# FOX DEN APARTMENTS WAUKESHA, WI

| Project: FOX DEN APARTMENTS<br>WAUKESHA, WI<br>SEGMENTAL RETAINING WALL PLANS |                       |                  |                     |
| Project No:<br>21CMC017   | Date:<br>15 JULY 2021 | Scale:<br>N.T.S. | Sheet No:<br>RW-1.0 |

**WALL 1 ELEVATION**  
DISTANCE SHOWN IN FEET ALONG FRONT FACE

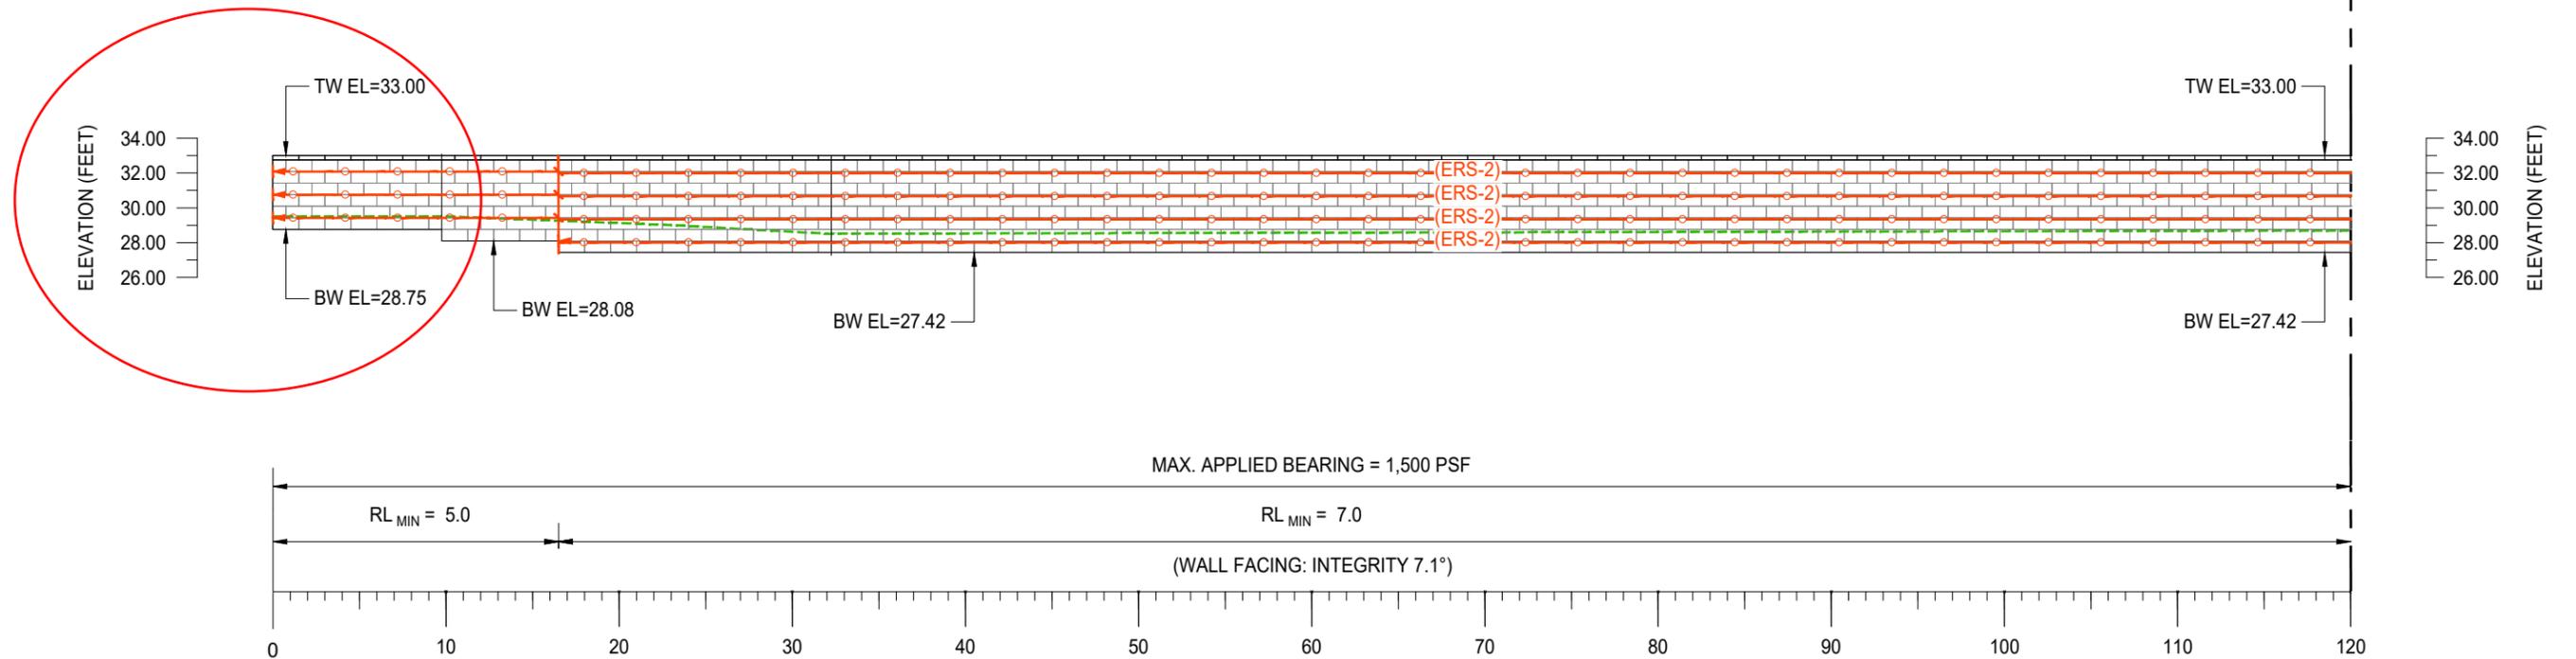
SEE CB#3, WALL 1  
NOW BLENDS INTO AN  
AREA WELL. DISTANCE  
WILL BE REDUCED
